# HISTORIC AND DESIGN REVIEW COMMISSION

April 15, 2015

Agenda Item No: 22

**HDRC CASE NO:** 2015-112  
**ADDRESS:** 268 W MARIPOSA - Detached garage  
**LEGAL DESCRIPTION:** NCB 9013 BLK 7 LOT 11 12 AND 13  
**ZONING:** R4 H  
**CITY COUNCIL DIST.:** 1  
**DISTRICT:** Olmos Park Terrace Historic District  
**APPLICANT:** Jose Cueva  
**OWNER:** Janet Vasquez  
**TYPE OF WORK:** Demolish existing garage and construct small cottage  
**REQUEST:**

## FLOOR PLAN

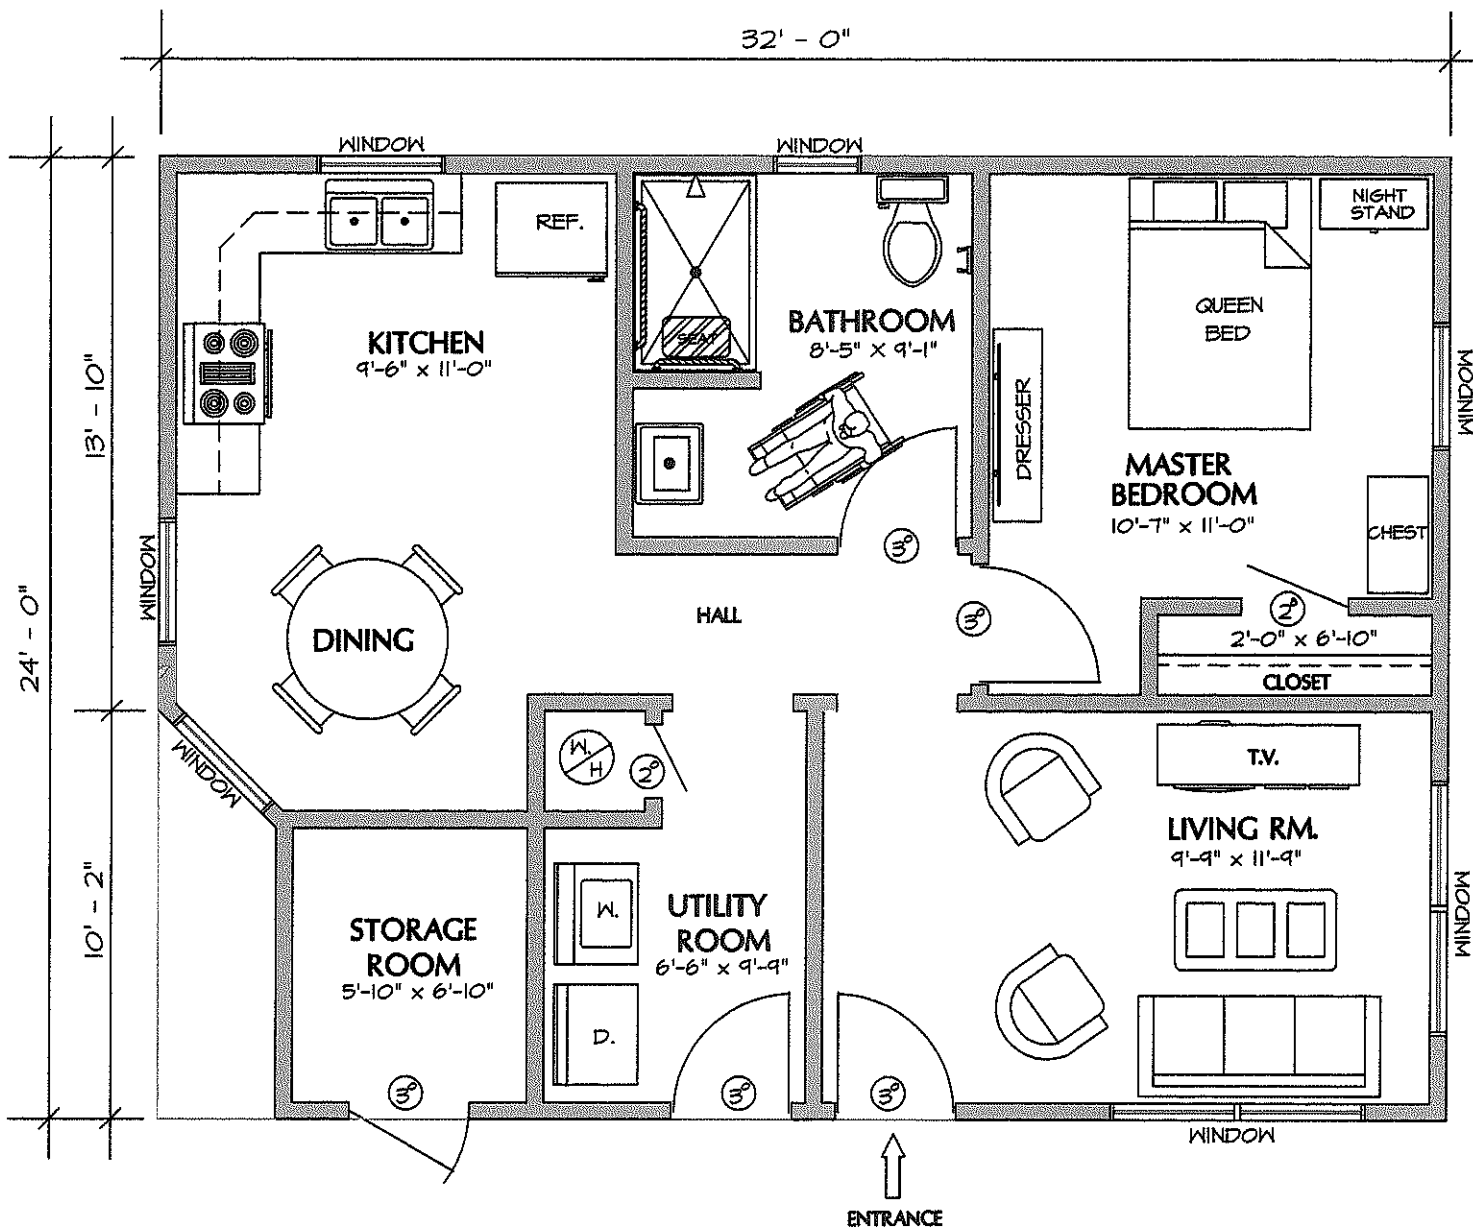
- e. Consistent with the Guidelines for New Construction, outbuildings should be visually subordinate to the main structure, should not be larger than 40% of the footprint of the main structure, and should relate to the main structure through the use of complementary materials and details. The proposed cottage is consistent with the guidelines in form, mass and size.

- f. According to the Guidelines for New Construction, historic setback patterns should be followed for new outbuildings. The proposed cottage will match the side setback on the existing structure and expand the rear wall to meet the rear setback. The proposed setbacks are consistent with the guidelines. However, the new structure might encroach on the side setback which may require a variance.

NORTH ELEVATION

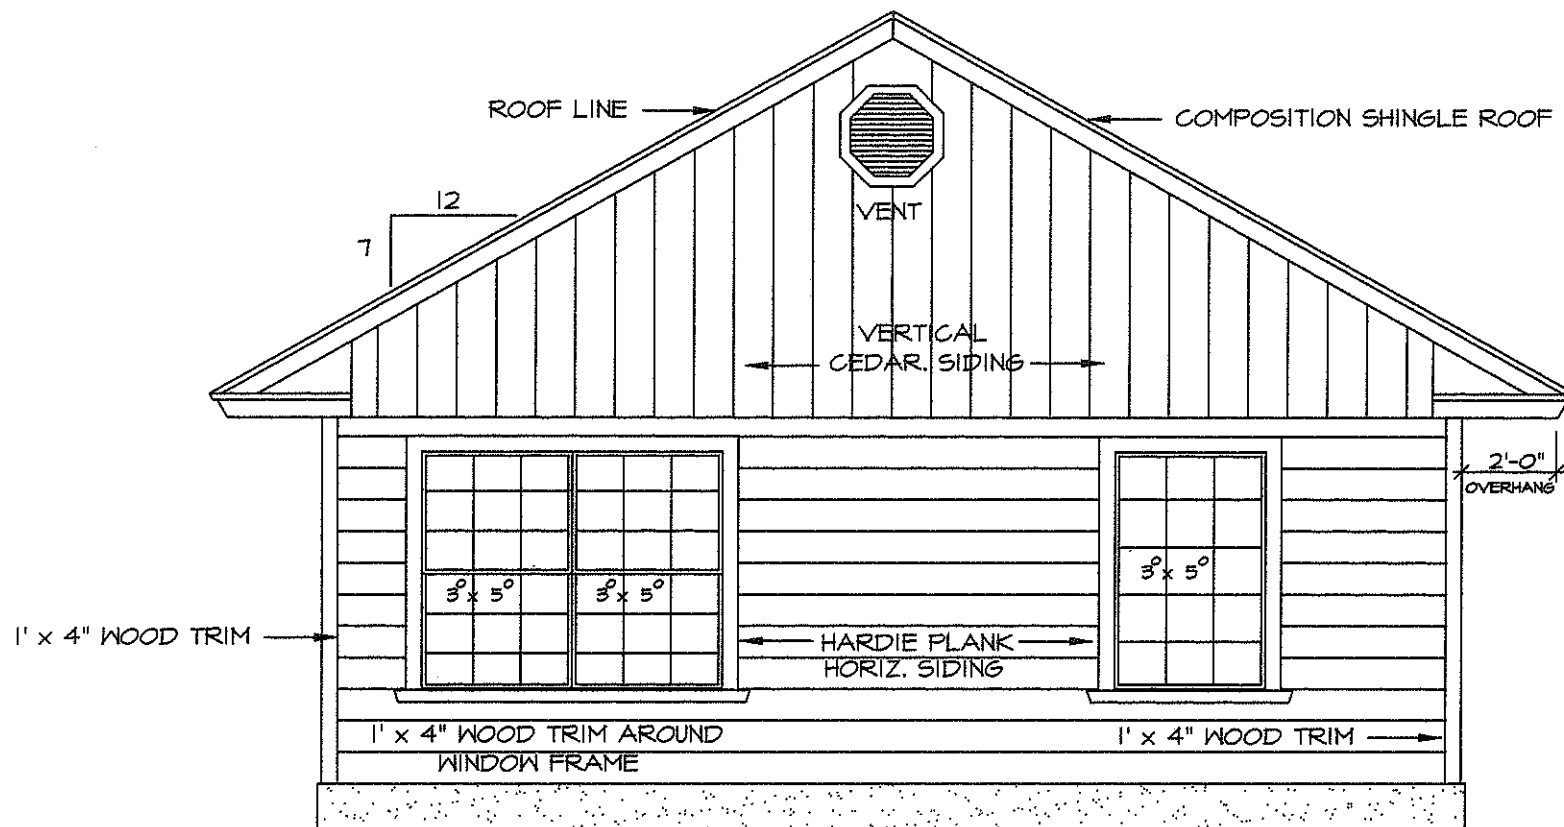
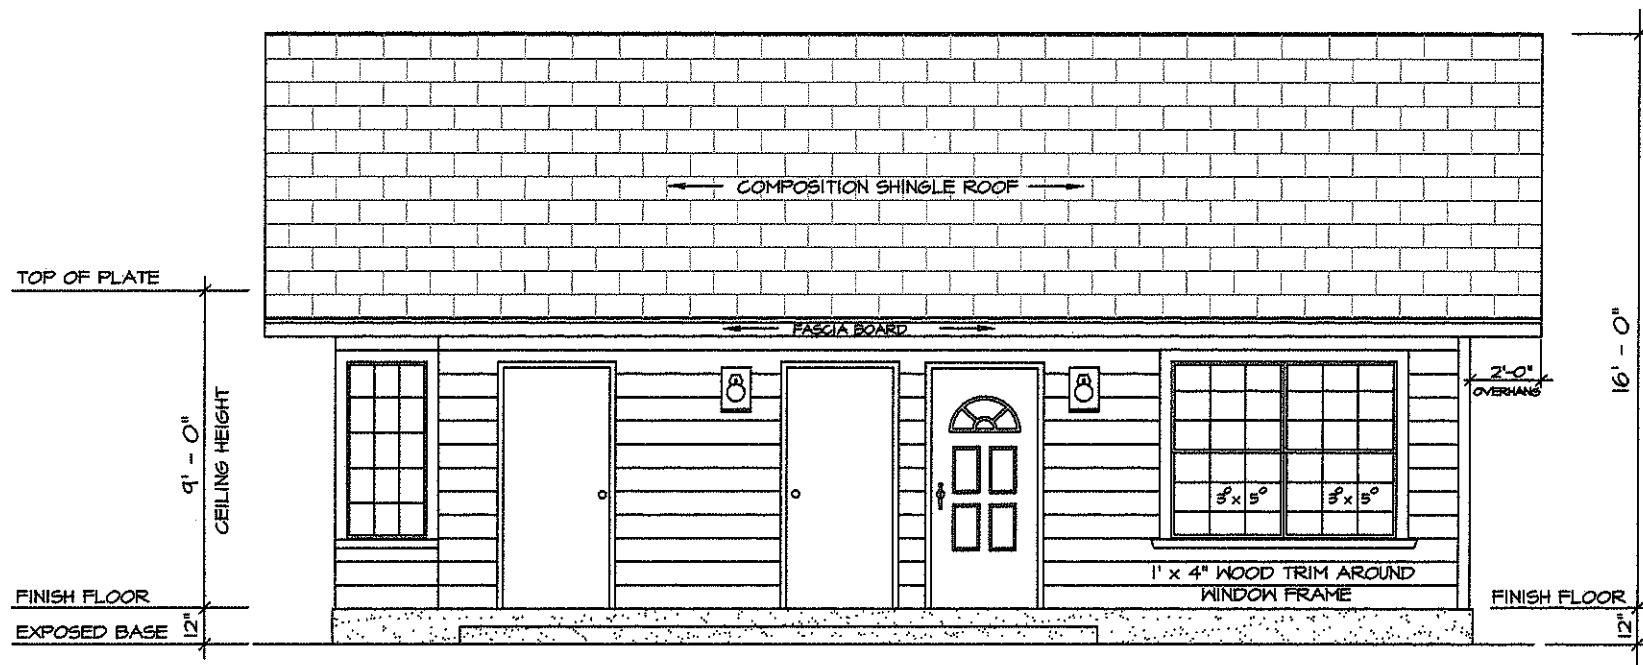
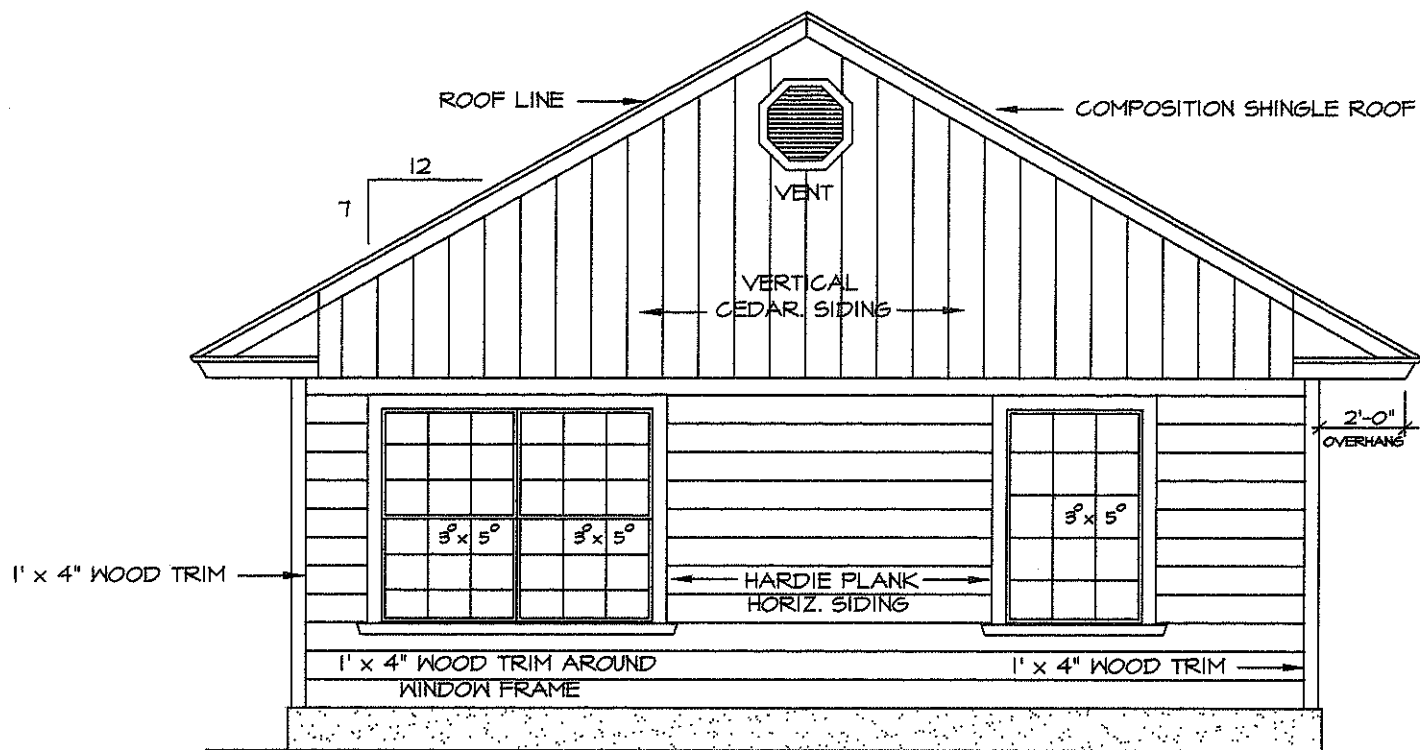
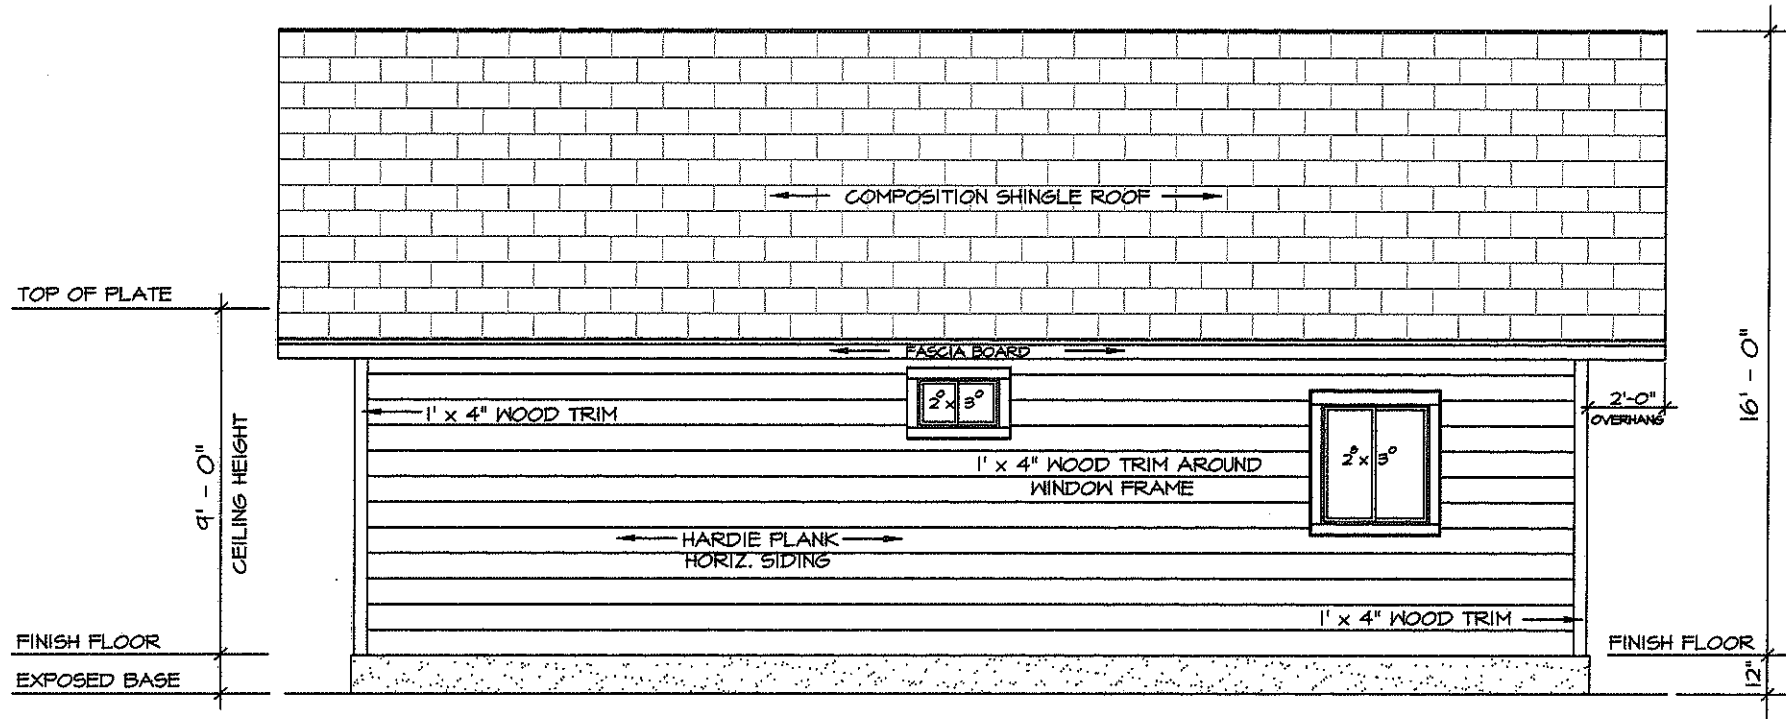
- g. The Guidelines for New Construction recommend new outbuildings to have window and door openings similar to those found on the principle structure in terms of spacing and proportions. The proposed windows are consistent in proportions to the main house. However, the proposed nine over nine aluminum windows will not match the six over six true divided lite windows on the house which should be avoided. In addition, the proposed doors are not a typically found door type in historic districts and does not relate to the historic home.

- h. New construction in historic districts should be complementary to historic structures found throughout the district. The applicant's proposal exhibits various details that are not consistent with the primary structure on the lot and therefore are not consistent with the Guidelines for New Construction which includes issues with the eave and rafter details and the design of the attic vents.

- a. A door type that is consistent with those found in historic districts is used
- b. If windows with divided lites are used, they should match the windows on the main house and use true divided glass.
- c. Eave and rafter detailing and appropriate attic vents.
